Technical Service Bulletin

GROUP SUSPENSION	NUMBER 17-SS-004
DATE OCTOBER, 2017	MODEL(S) Elantra (AD)

SUBJECT: UPPER SIDE FRONT STRUT NOISE

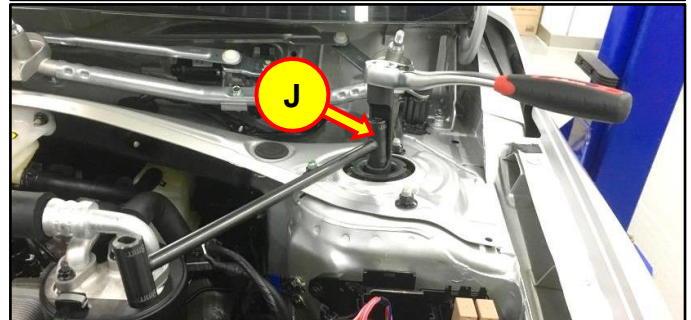
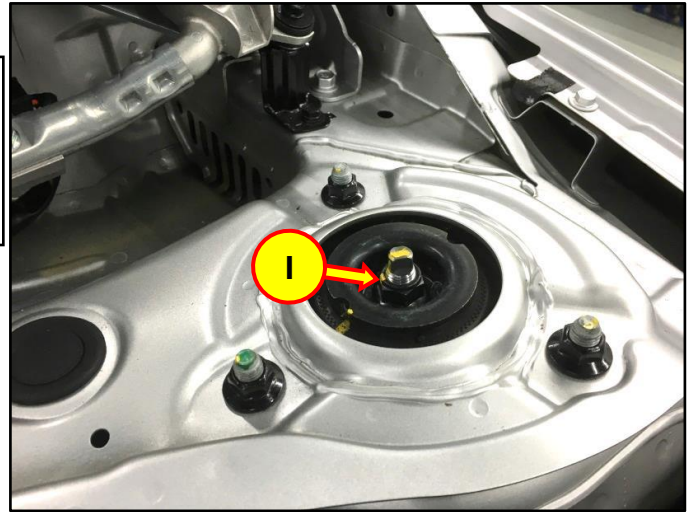
Do not use an impact tool when removing or installing the nut. Threads can be damaged. Always use the SST or equivalent and hand tools.

10. Remove the left and right strut nuts (I) using the SST P/N 09546-3X100 (J) or an equivalent tool.

Discard the nuts.

11. Install one (1) new strut nut on each side using the SST and a torque wrench.

Tightening torque:

98.0 ~ 107.8 N.m(10.0 ~ 11.0 kgf.m, 72.3 ~ 79.6 lb-ft)
